Arroyo Santa Rosa

Please note that the Ventura County Watershed Protection District (then Ventura County Flood Control District) submitted a request for a Letter of Map Revision (LOMR) in a letter to FEMA dated January 29, 1998 (see attachment 1, 1998 LOMR). The LOMR covers portions of the Arroyo Santa Rosa main channel, Arroyo Santa Rosa overflow, and Arroyo Santa Rosa Tributary, in the unincorporated area of Ventura County, California. FEMA approved the LOMR in a letter dated November 30, 1998 (Case No. 98-09-414P). The conclusions on flooding are different than those arrived by Nolte. A reason can be attributed to data used in hydraulic models does not correspond to field conditions. The following presents our case in further detail.

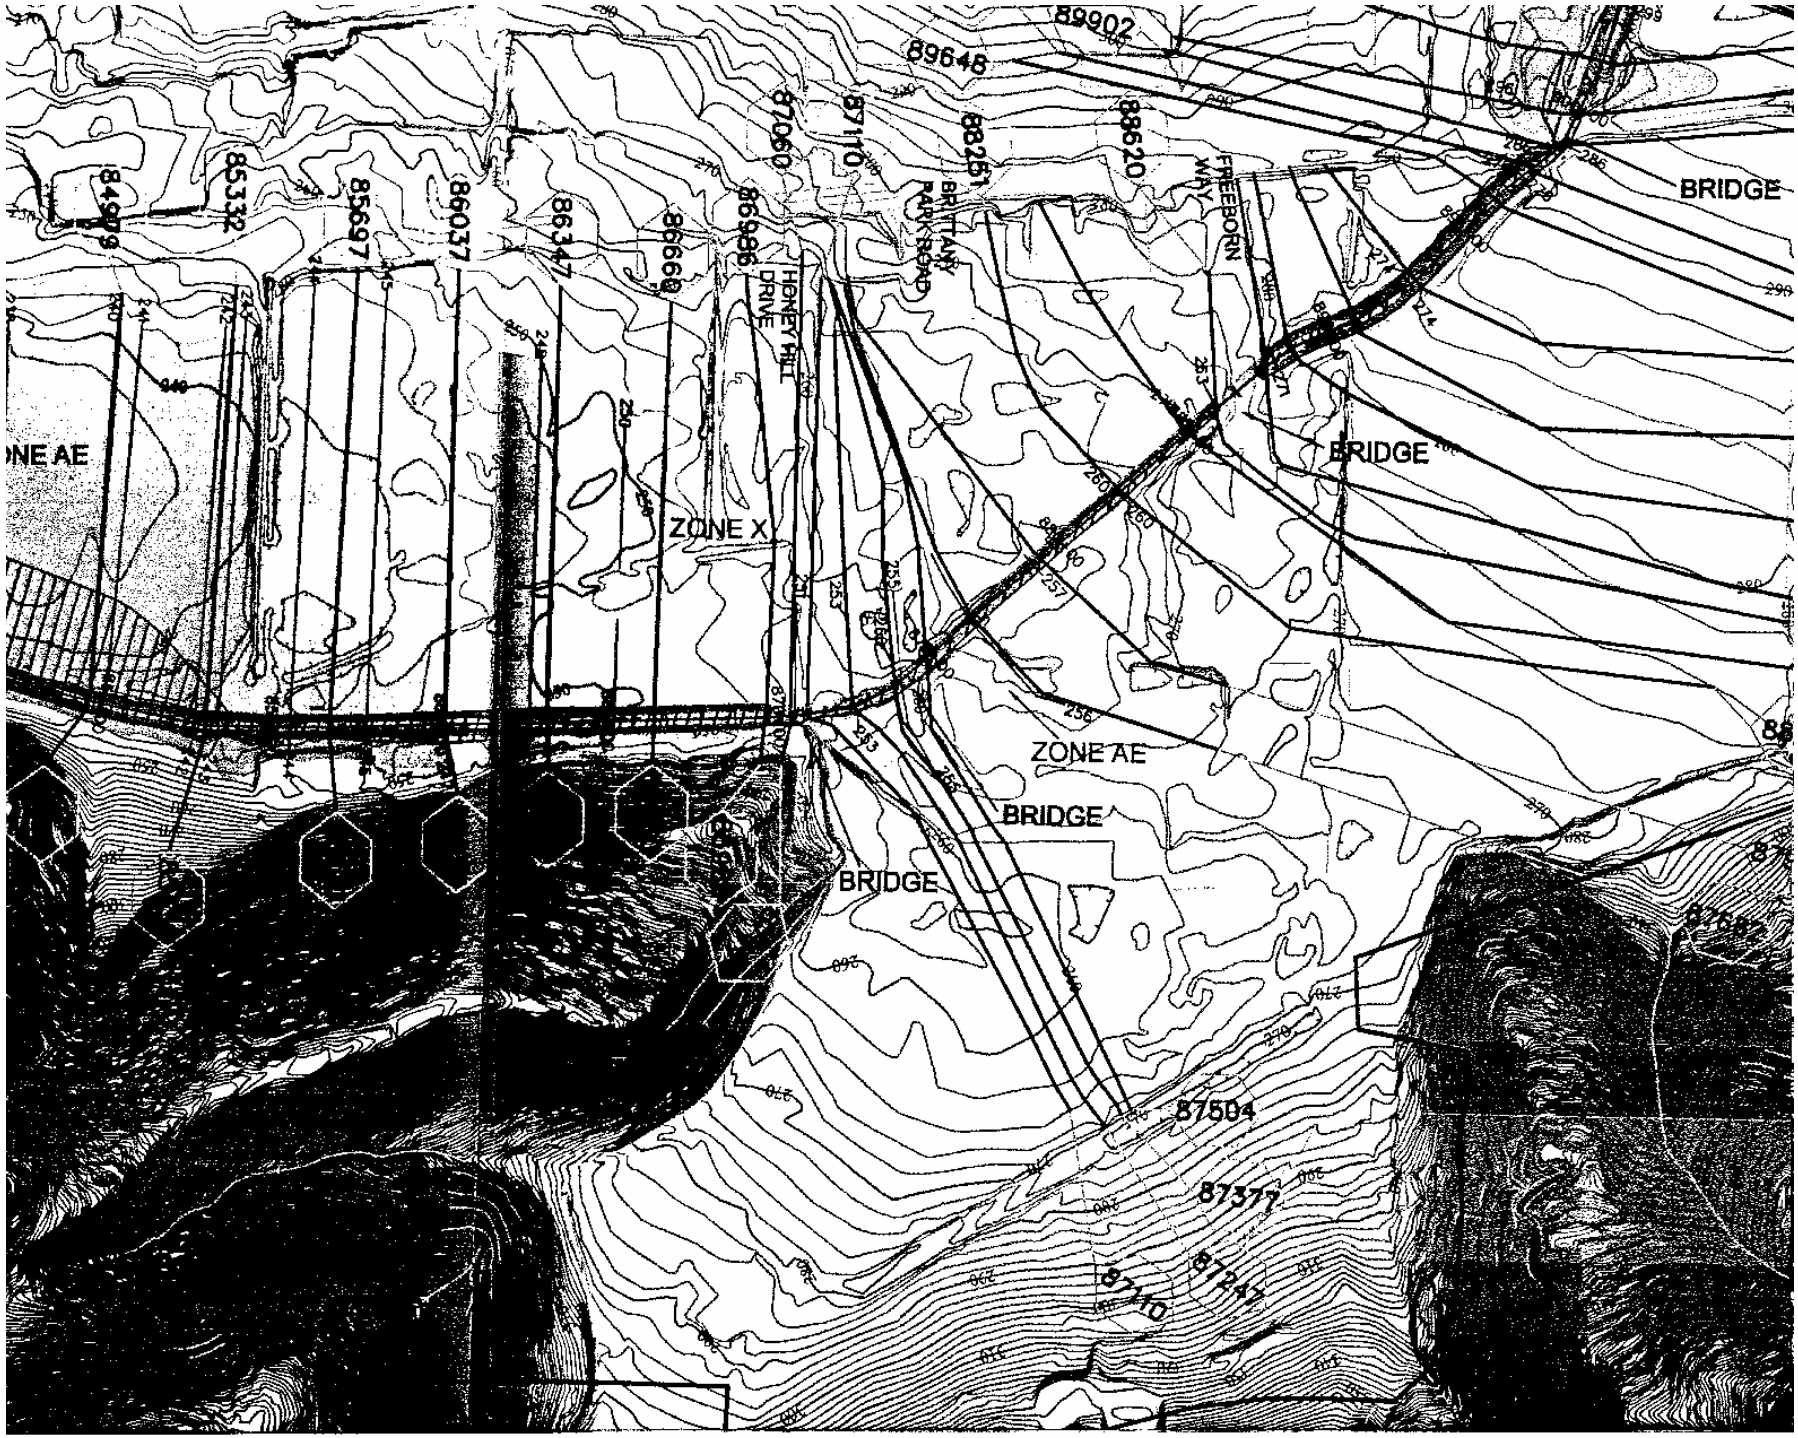
From Santa Rosa Road to Honey Hill Road (Approximately 3,000 Feet Long)
Arroyo Santa Rosa main channel from Santa Rosa Road to Honey Hill Road is a section of improved channel composed of rectangular RC open channel and trapezoidal rock riprap channel (see attachment 2, as-built drawings). For this section of channel, the 1998 LOMR concluded that the 100-year flood was contained in channel. The Nolte 2005 FIS, nevertheless, shows a floodplain as well as a floodway outside the improved concrete rectangular channel.

After reviewing the Nolte FIS hydraulic calculations in the HEC-RAS models (ArroyoSantaRosa.prj; ArroyoSantaRosa_Floodway.prj), it is evident that the following errors may have to the incorrect floodplain/floodway designation:

1. Incorrect coding of channel geometry:
   From Freeborn Way to Honey Hill Road, the channel is a 20 feet wide 12 feet high rectangular concrete channel. However, the model shows a trapezoidal channel with incorrect invert elevations. The inverts of the trapezoidal channel from Santa Rosa Road to Freeborn Way also do not match the as-built drawings (see attachment 2). A comparison of HEC-RAS profiles based on Nolte 2005 FIS and as-built drawings is shown in Figure 1.

2. Incorrect selection of channel roughness coefficients:
   For the concrete rectangular channel, the model uses a roughness coefficient of 0.035 instead of a commonly used value of 0.015. This greatly underestimated the channel capacity.

From Honey Hill Road to Approximately 2,750 Feet Downstream
This section of channel is an improved trapezoidal earth channel (see attachment 2). For this graded regular earth channel with grass and weeds, it is more appropriate to use a roughness coefficient of 0.035 to 0.05. By using a value of 0.06 to 0.07, Nolte FIS greatly underestimated the channel capacity, and as a result, a wider floodplain was generated.

A duplicate effective model is included which better represents actual physical conditions of the study reach. The duplicate effective models have been created based on Nolte HEC-RAS models with corrections on channel geometry and roughness coefficients. A print-out of the duplicate effective models is attached in Attachment 5.

Revised floodplain/floodway maps are shown in Attachment 6.
